TRANSMITTAL COVER SHEET

DATE: 21 June, 2024
TO: ALL PLAN HOLDERS OF RECORD
FROM: HUNTER SWATEK, AIA, PROJECT MANAGER
PROJECT: RAINBOW CITY RECREATION CENTER
GMC PROJECT NO. ABHM230021
RE: ADDENDUM NO. 3 AND
ACKNOWLEDGEMENT OF RECEIPT OF ADDENDUM NO. 3

ADDENDUM NUMBER 03

**PROJECT: RAINBOW CITY RECREATION CENTER
GM&C PROJECT NO. ABHM230021**

AMPHITHEATRE PLANS

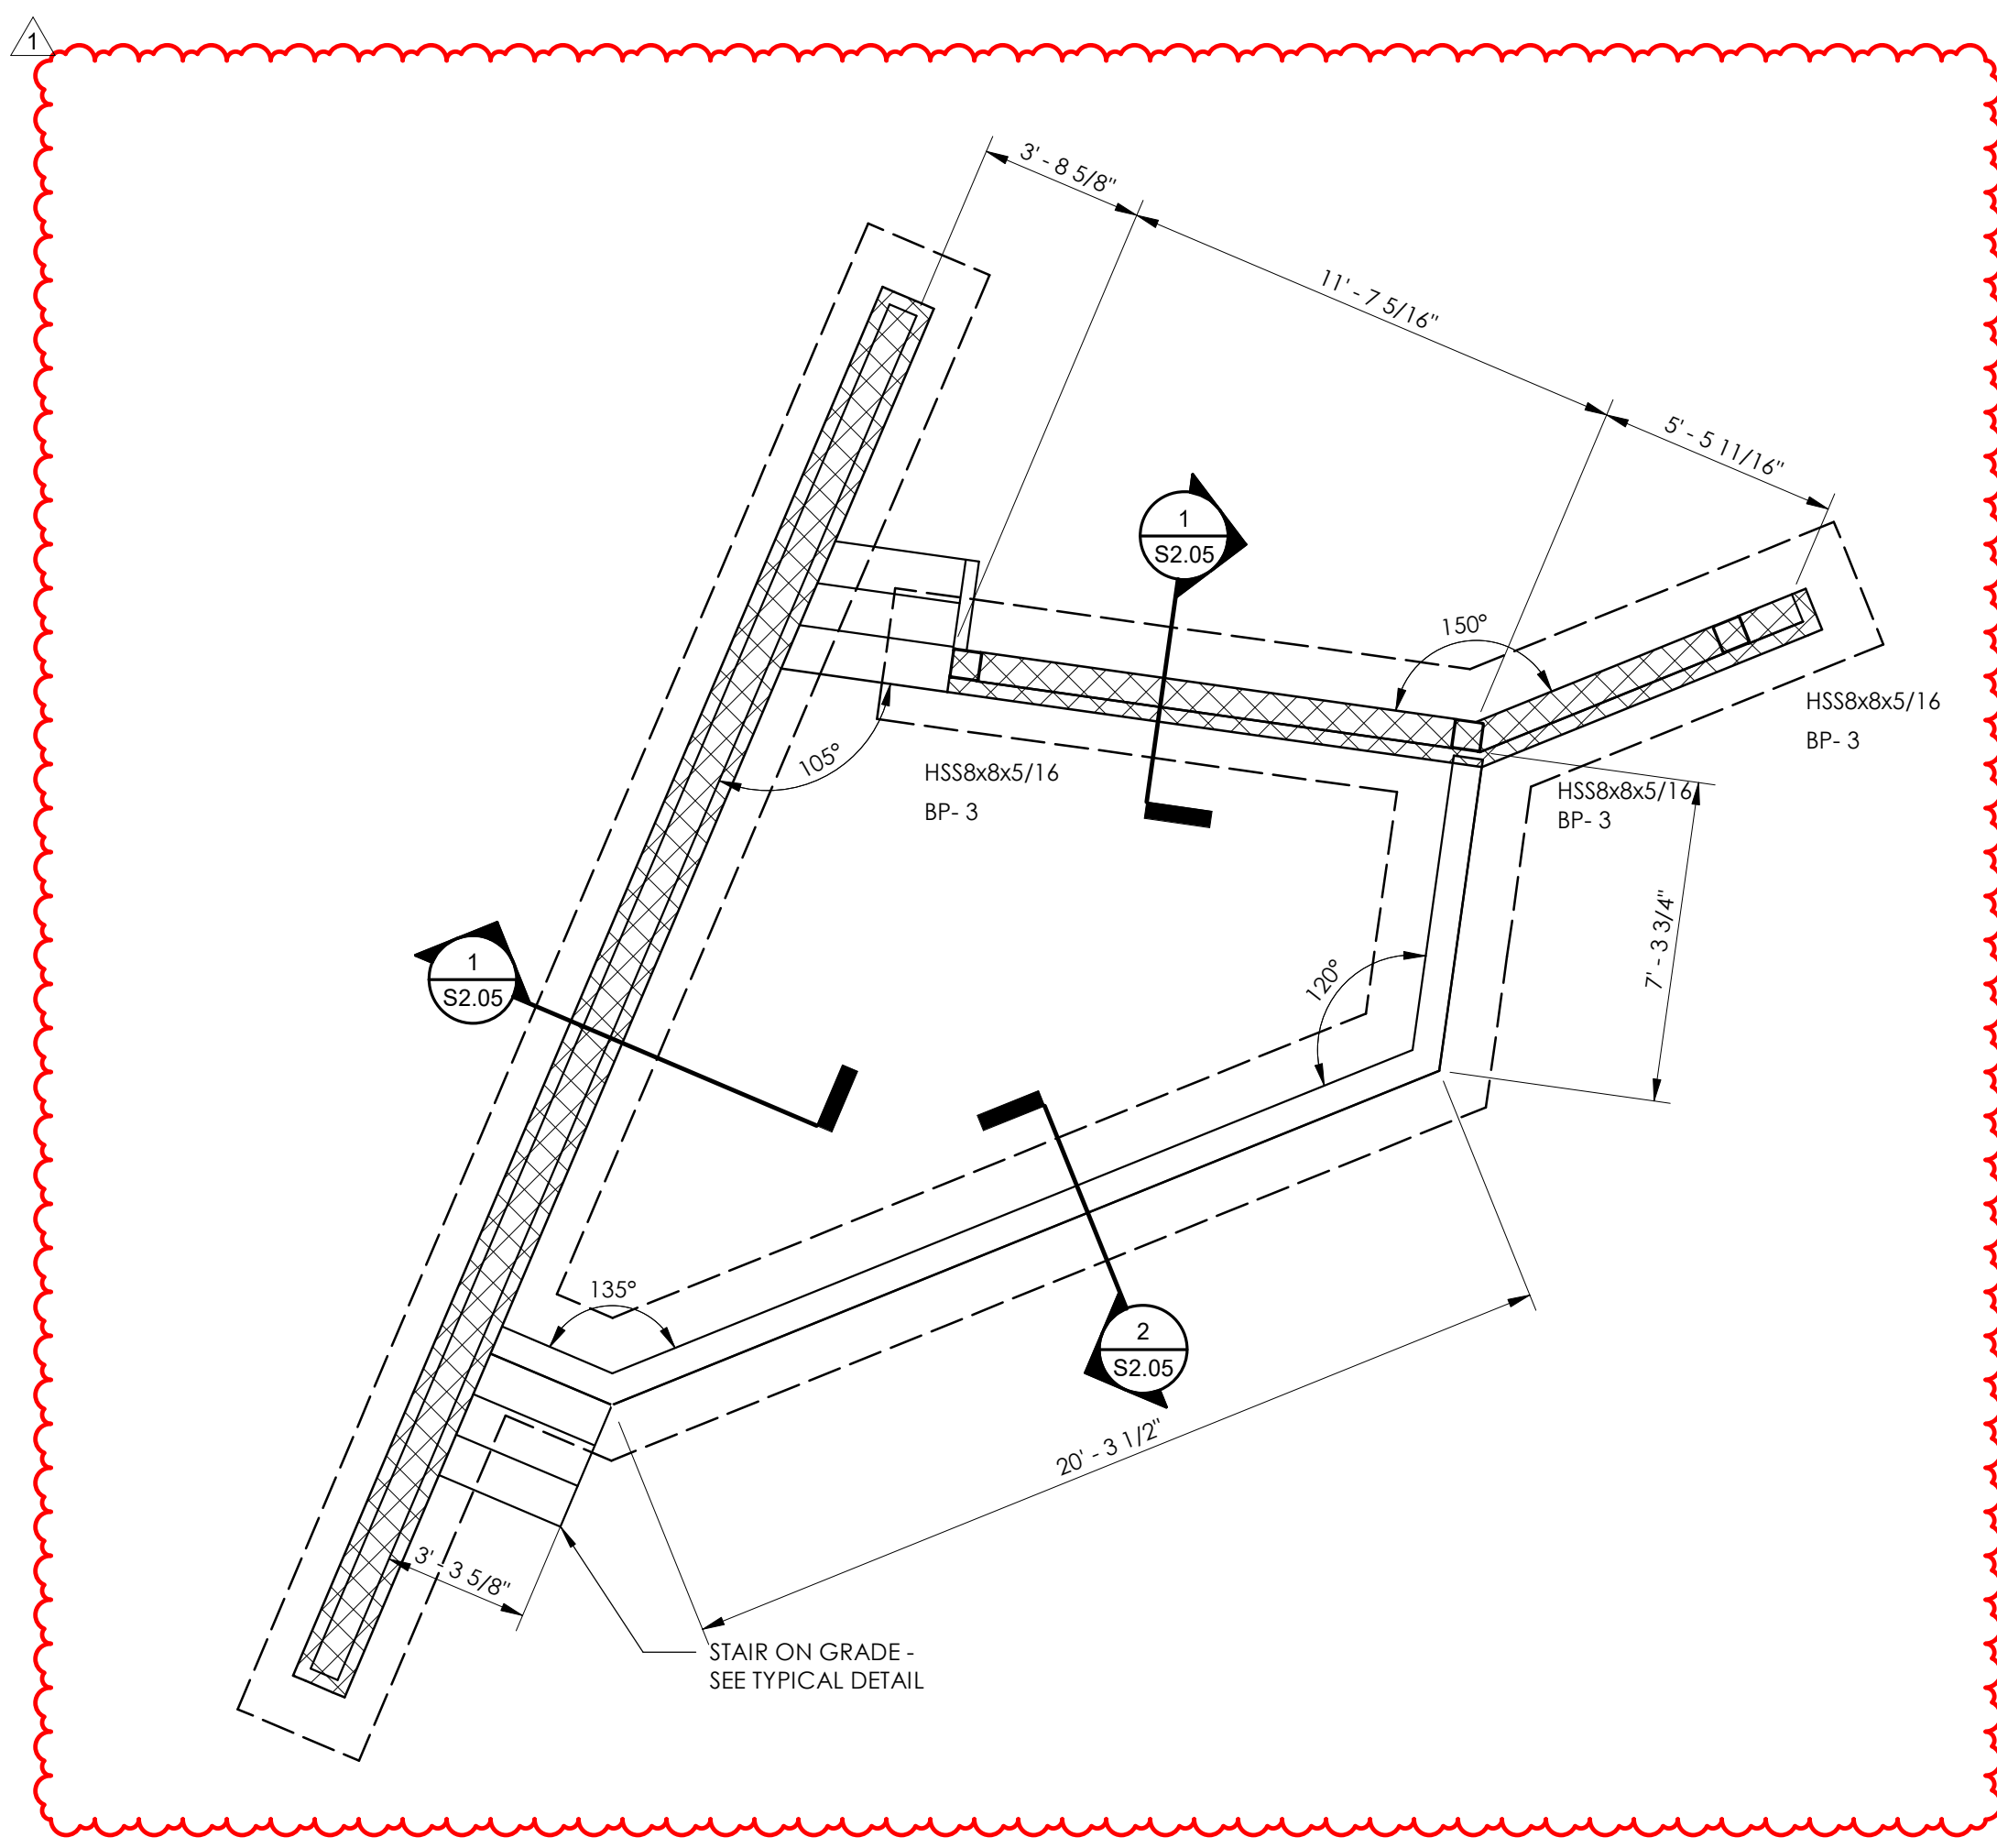
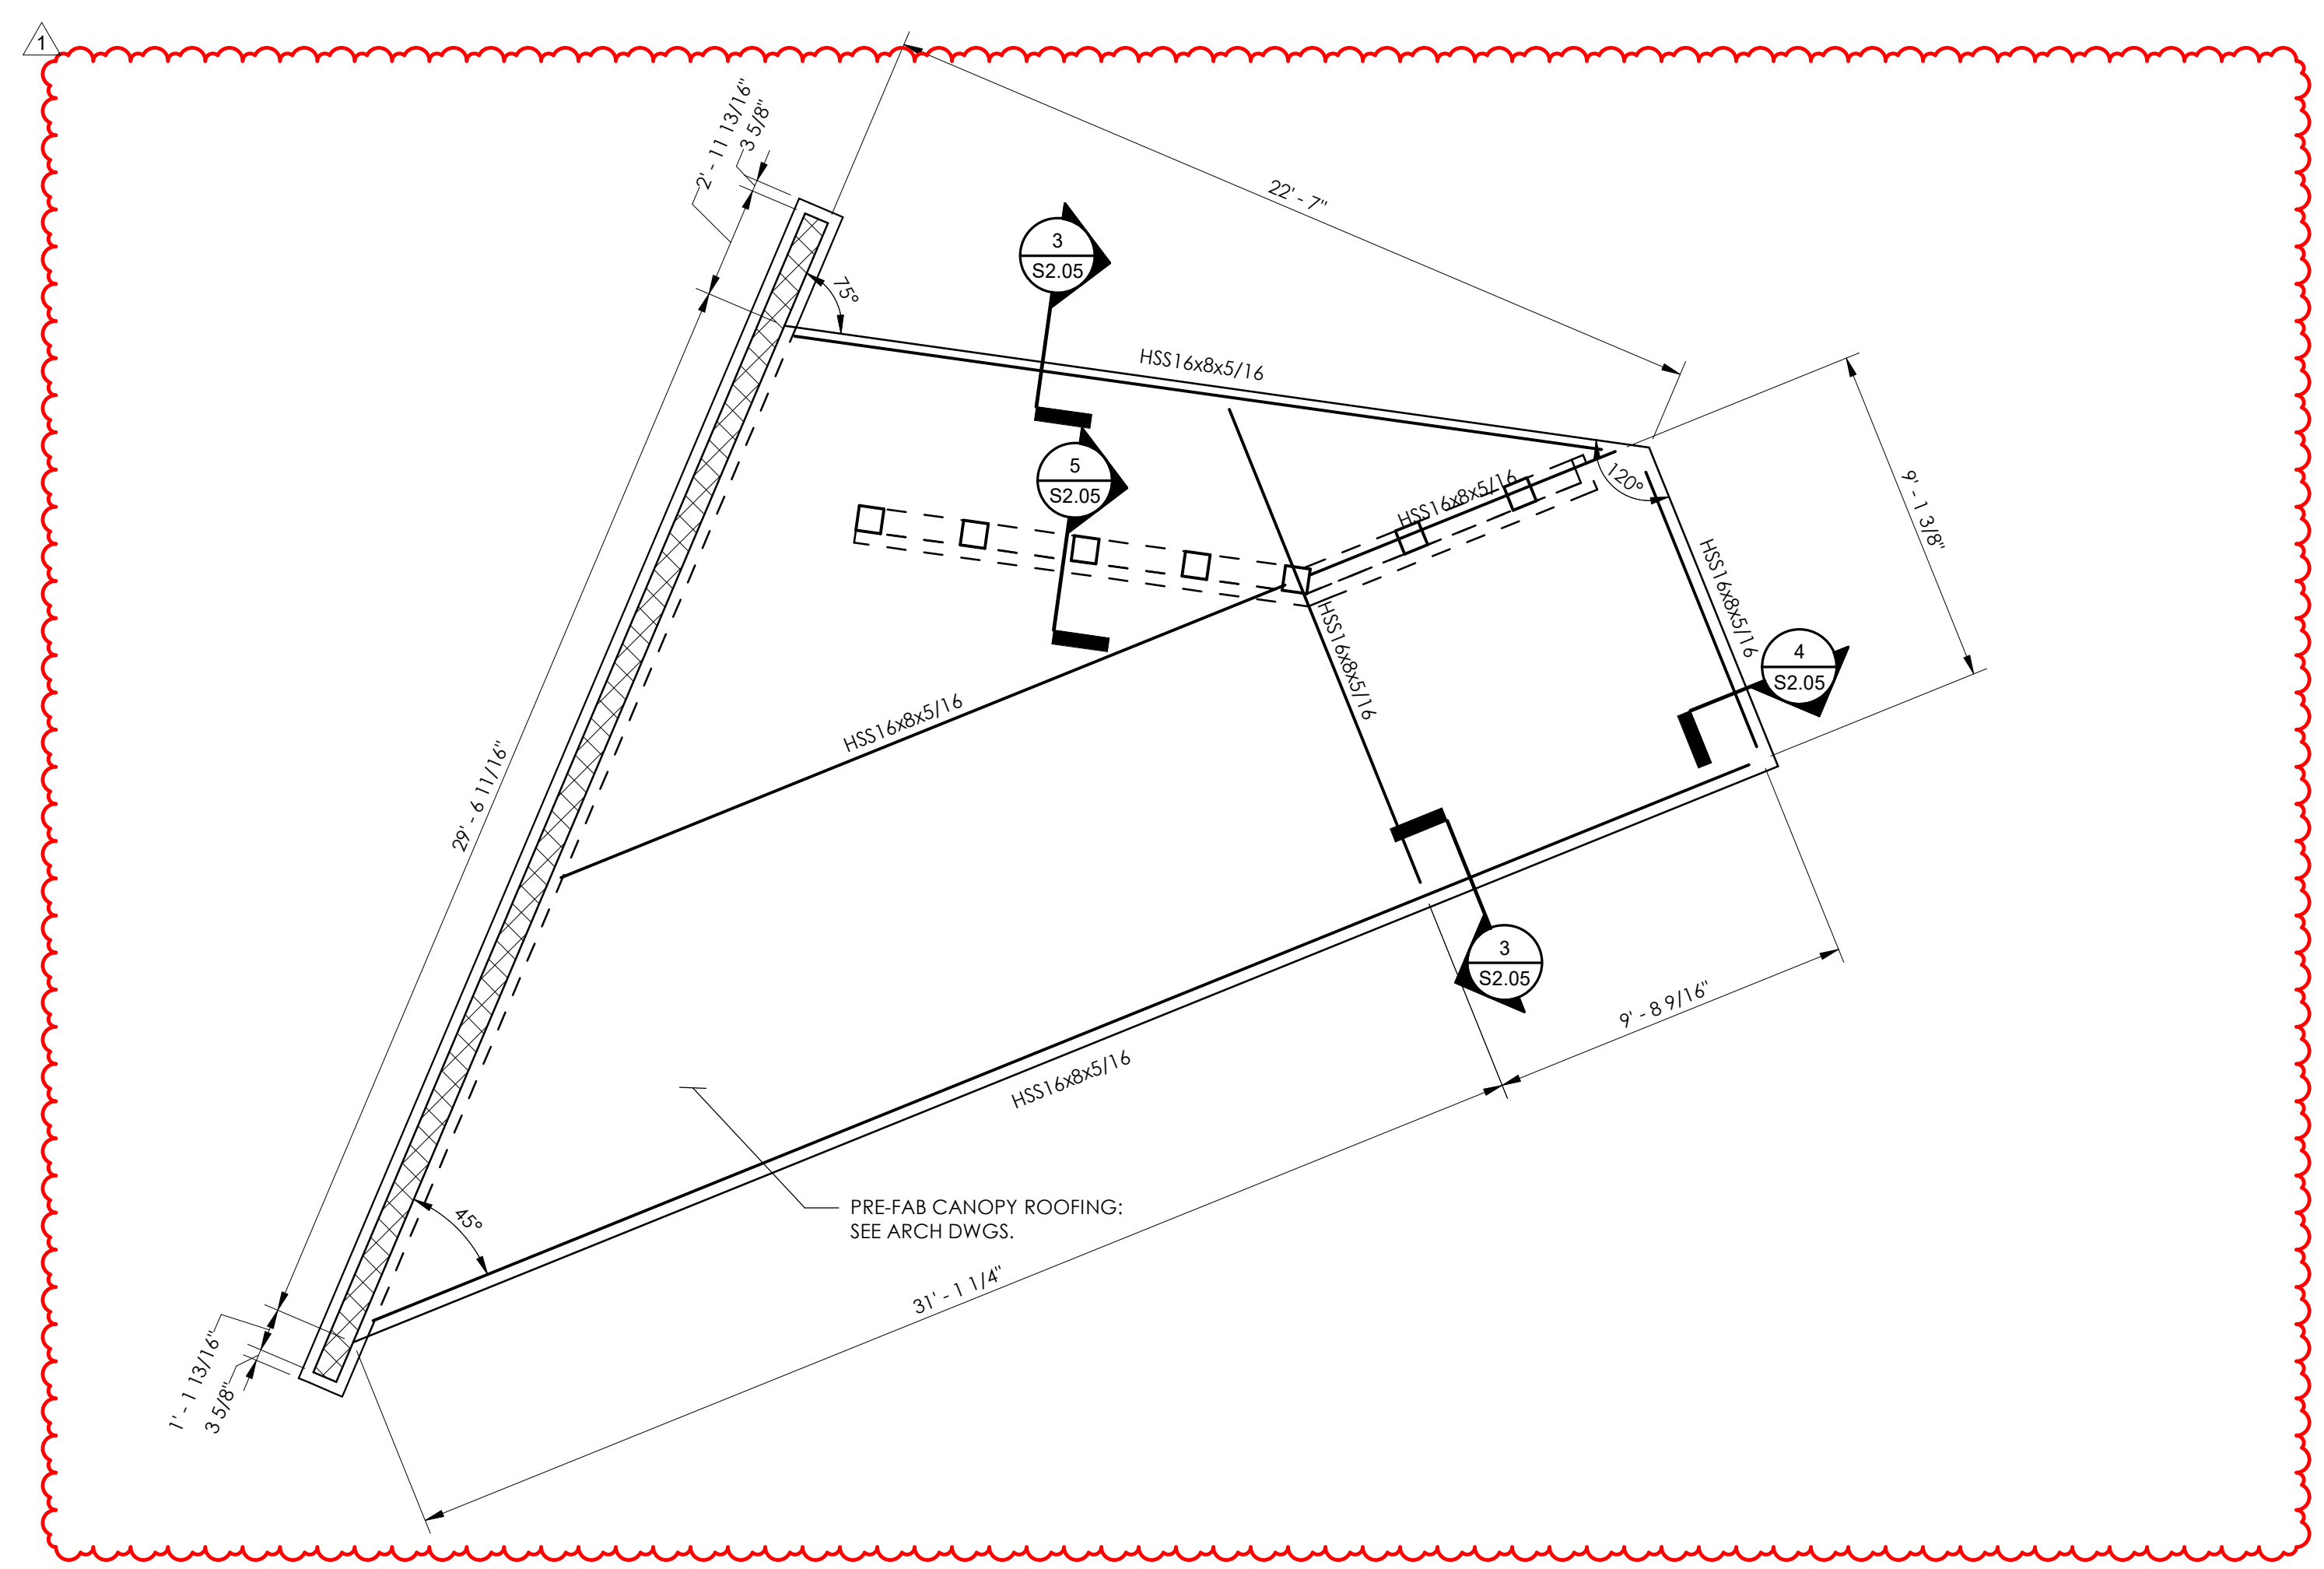
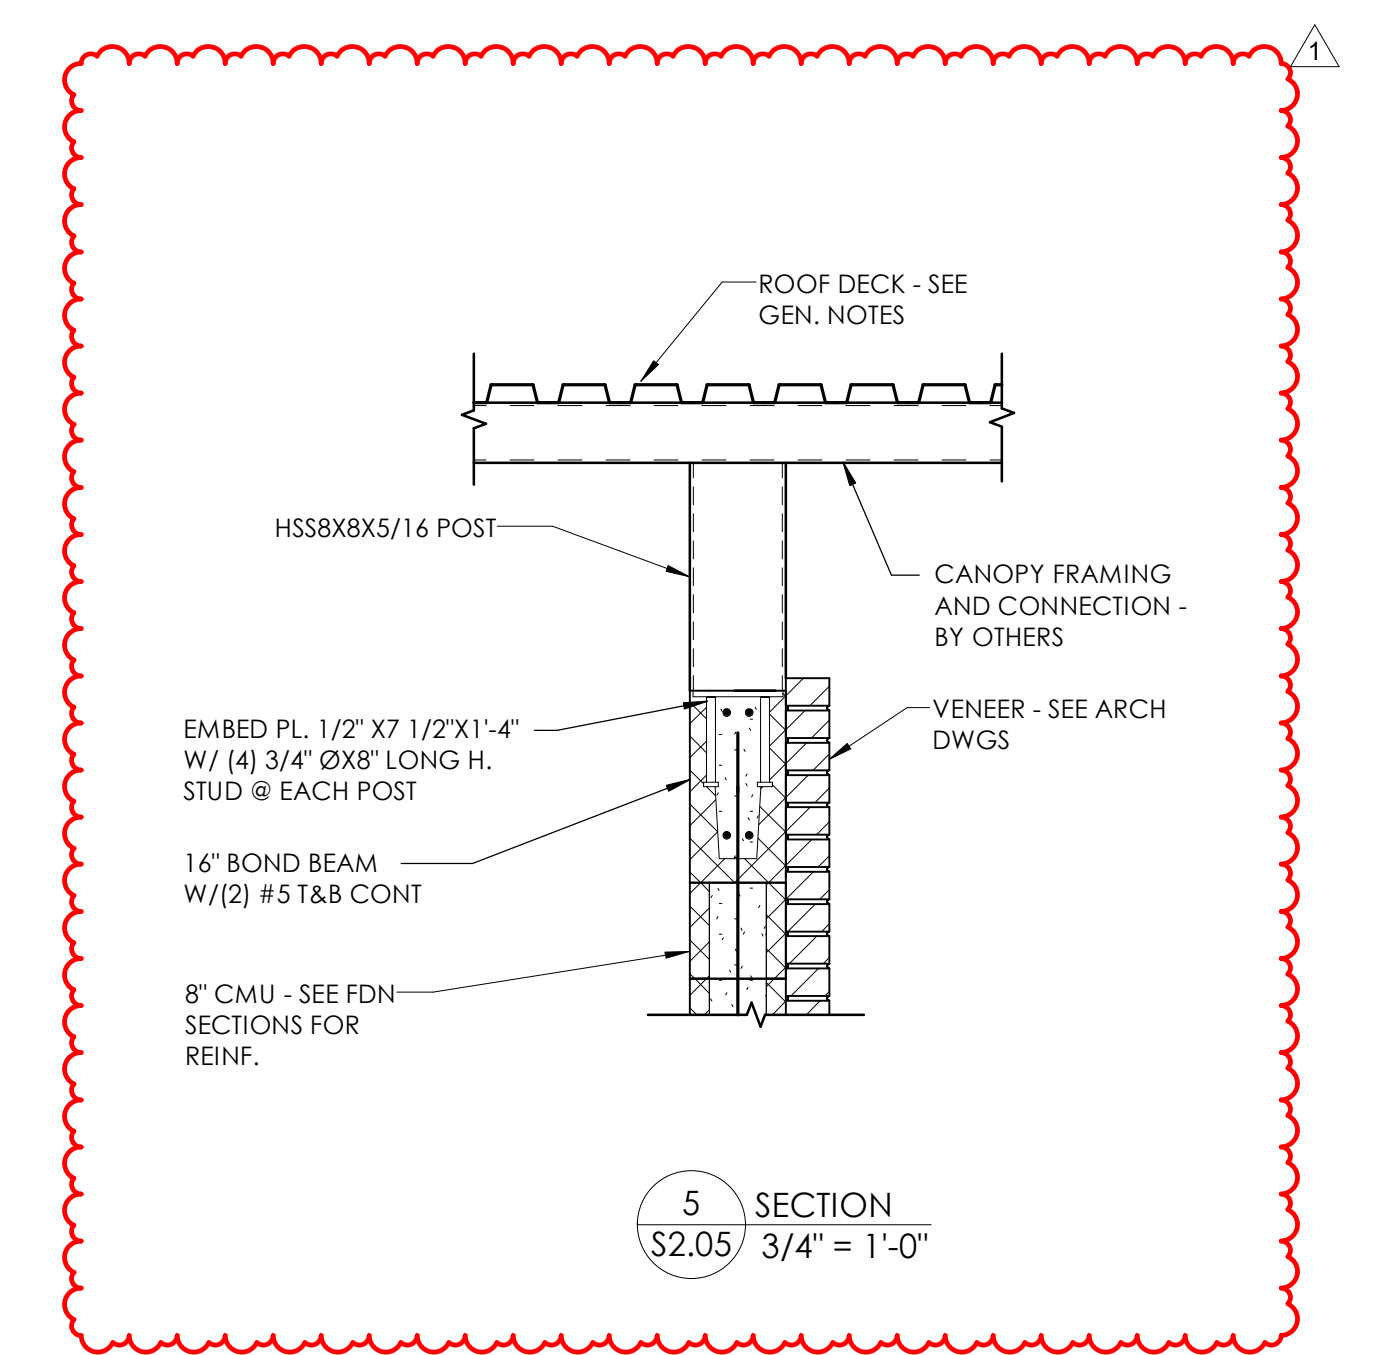
- a. REVISED Partitions and thickened slab
 - b. ADDED Sump pits
- W. **S2.05** – Amphitheatre Plans
 - a. ADDED Dimensions
 - b. ADDED Section
- X. **S3.01** – Sections
